DAVIS-BESSE NUCLEAR POWER STATION UNIT 1

IMPROVED TECHNICAL SPECIFICATION CONVERSION LICENSE AMENDMENT REQUEST

VOLUME 5 (Rev. 1)

SECTION 3.0 – LCO AND SR APPLICABILITY

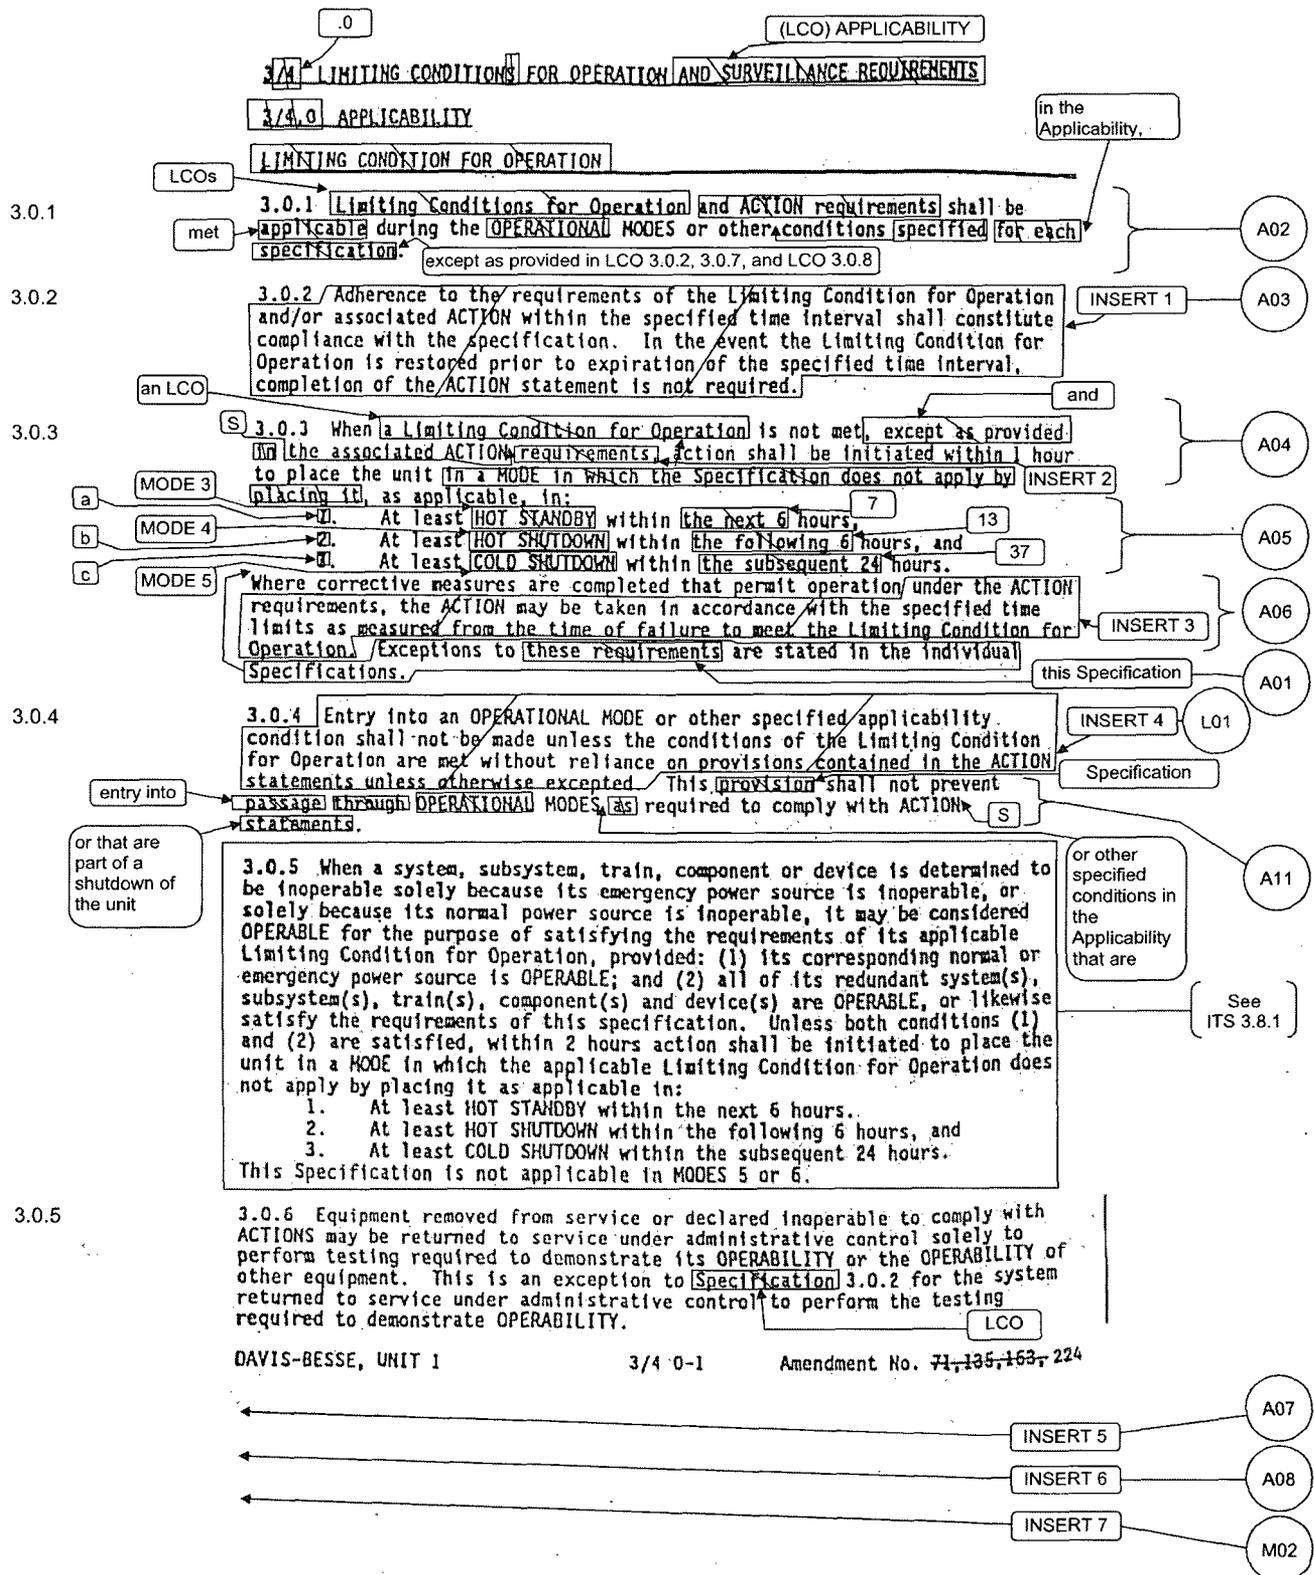
A01

A03

INSERT 1

Upon discovery of a failure to meet an LCO, the Required Actions of the associated Conditions shall be met, except as provided in LCO 3.0.5 and LCO 3.0.6.

If the LCO is met or is no longer applicable prior to expiration of the specified Completion Time(s), completion of the Required Action(s) is not required, unless otherwise stated.

INSERT 2

are not met, an associated ACTION is not provided, or if directed by the associated ACTIONS, the unit shall be placed in a MODE or other specified condition in which the LCO is not applicable.

A04
A01

A06

INSERT 3

in accordance with the LCO or ACTIONS, completion of the actions required by LCO 3.0.3 is not required.

LCO 3.0.3 is only applicable in MODES 1, 2, 3, and 4.

L01

INSERT 4

LCO 3.0.4

When an LCO is not met, entry into a MODE or other specified condition in the Applicability shall only be made:

- a. When the associated ACTIONS to be entered permit continued operation in the MODE or other specified condition in the Applicability for an unlimited period of time;
- b. After performance of a risk assessment addressing inoperable systems and components, consideration of the results, determination of the acceptability of entering the MODE or other specified condition in the Applicability, and establishment of risk management actions, if appropriate; exceptions to this Specification are stated in the individual Specifications; or
- c. When an allowance is stated in the individual value, parameter, or other Specification.

A07

INSERT 5

LCO 3.0.6

When a supported system LCO is not met solely due to a support system LCO not being met, the Conditions and Required Actions associated with this supported system are not required to be entered. Only the support system LCO ACTIONS are required to be entered. This is an exception to LCO 3.0.2 for the supported system. In this event, an evaluation shall be performed in accordance with Specification 5.5.14, "Safety Function Determination Program (SFDP)." If a loss of safety function is determined to exist by this program, the appropriate Conditions and Required Actions of the LCO in which the loss of safety function exists are required to be entered.

When a support system's Required Action directs a supported system to be declared inoperable or directs entry into Conditions and Required Actions for a supported system, the applicable Conditions and Required Actions shall be entered in accordance with LCO 3.0.2.

A08

INSERT 6

LCO 3.0.7 Test Exception LCOs 3.1.8 and 3.1.9 allow specified Technical Specification (TS) requirements to be changed to permit performance of special tests and operations. Unless otherwise specified, all other TS requirements remain unchanged. Compliance with Test Exception LCOs is optional. When a Test Exception LCO is desired to be met but is not met, the ACTIONS of the Test Exception LCO shall be met. When a Test Exception LCO is not desired to be met, entry into a MODE or other specified condition in the Applicability shall be made in accordance with the other applicable Specifications.

M02

INSERT 7

LCO 3.0.8 When one or more required snubbers are unable to perform their associated support function(s), any affected supported LCO(s) are not required to be declared not met solely for this reason if risk is assessed and managed, and:

- a. the snubbers not able to perform their associated support function(s) are associated with only one train or subsystem of a multiple train or subsystem supported system or are associated with a single train or subsystem supported system and are able to perform their associated support function within 72 hours; or
- b. the snubbers not able to perform their associated support function(s) are associated with more than one train or subsystem of a multiple train or subsystem supported system and are able to perform their associated support function within 12 hours.

At the end of the specified period the required snubbers must be able to perform their associated support function(s), or the affected supported system LCO(s) shall be declared not met.

3/4 0-2

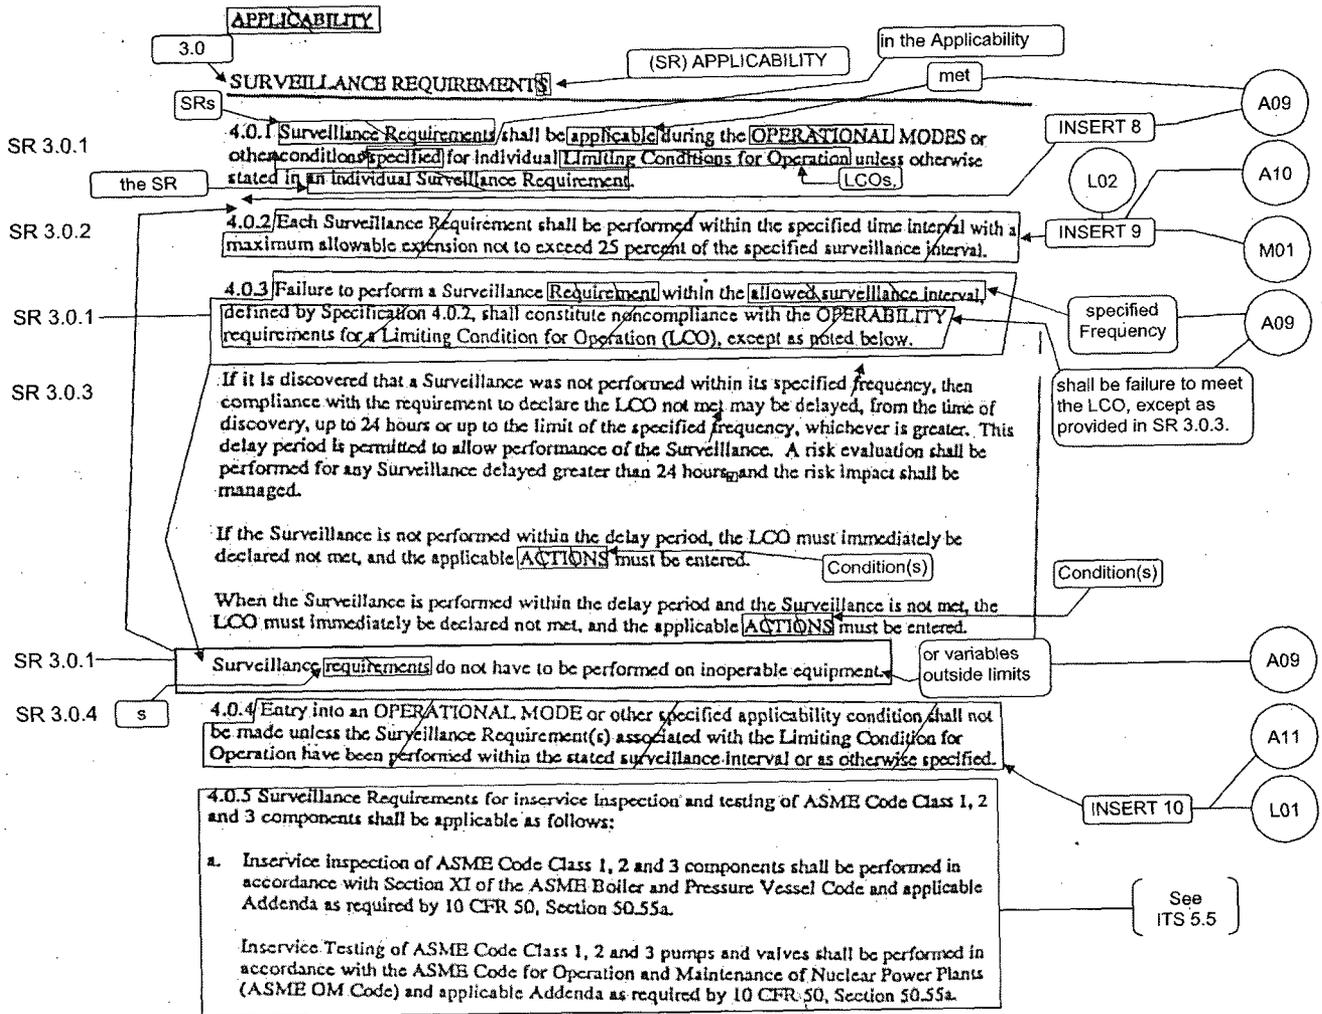
A09

INSERT 8

Failure to meet a Surveillance, whether such failure is experienced during the performance of the Surveillance or between performances of the Surveillance, shall be failure to meet the LCO.

INSERT 9

SR 3.0.2

The specified Frequency for each SR is met if the Surveillance is performed within 1.25 times the interval specified in the Frequency, as measured from the previous performance or as measured from the time a specified condition of the Frequency is met.

A10

For Frequencies specified as "once," the above interval extension does not apply.

M01

If a Completion Time requires periodic performance on a "once per . . ." basis, the above Frequency extension applies to each performance after the initial performance.

L02

Exceptions to this Specification are stated in the individual Specifications.

A10

INSERT 10

SR 3.0.4

Entry into a MODE or other specified condition in the Applicability of an LCO shall only be made when the LCO's Surveillances have been met within their specified Frequency, except as provided by SR 3.0.3. When an LCO is not met due to Surveillances not having been met, entry into a MODE or other specified condition in the Applicability shall only be made in accordance with LCO 3.0.4.

L01

This provision shall not prevent entry in MODES or other specified conditions in the Applicability that are required to comply with ACTIONS or that are part of a shutdown of the unit.

LCO 3.0.6 (continued)

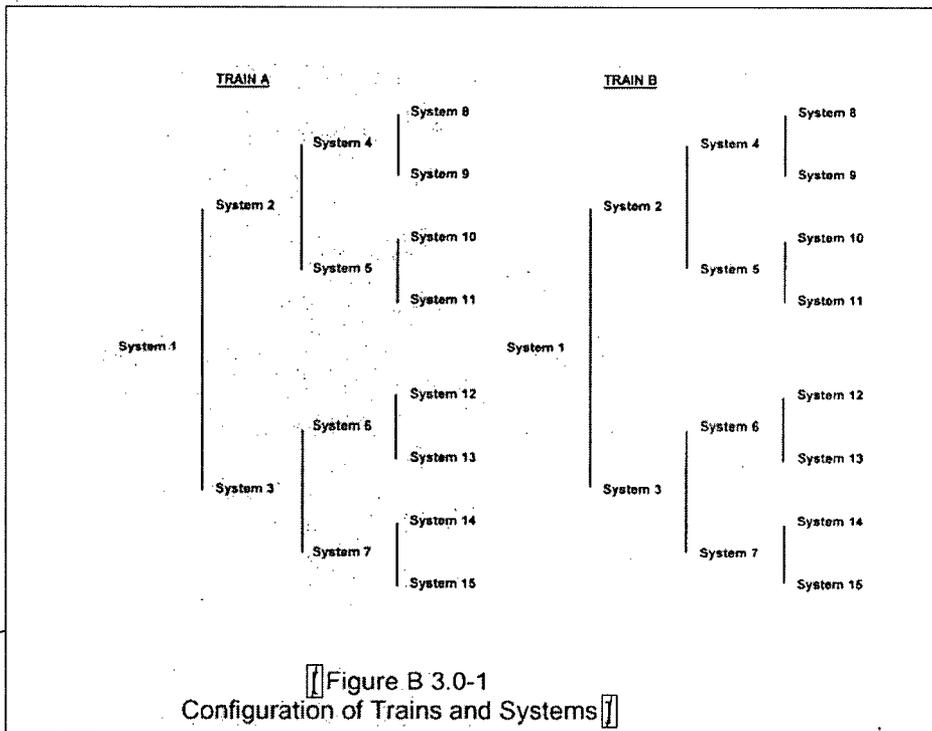
(move to end of Section)

6. The Figure has been moved to the end of the Section, consistent with the format of the ITS.
7. These changes are made to be consistent with LCO 3.0.7.
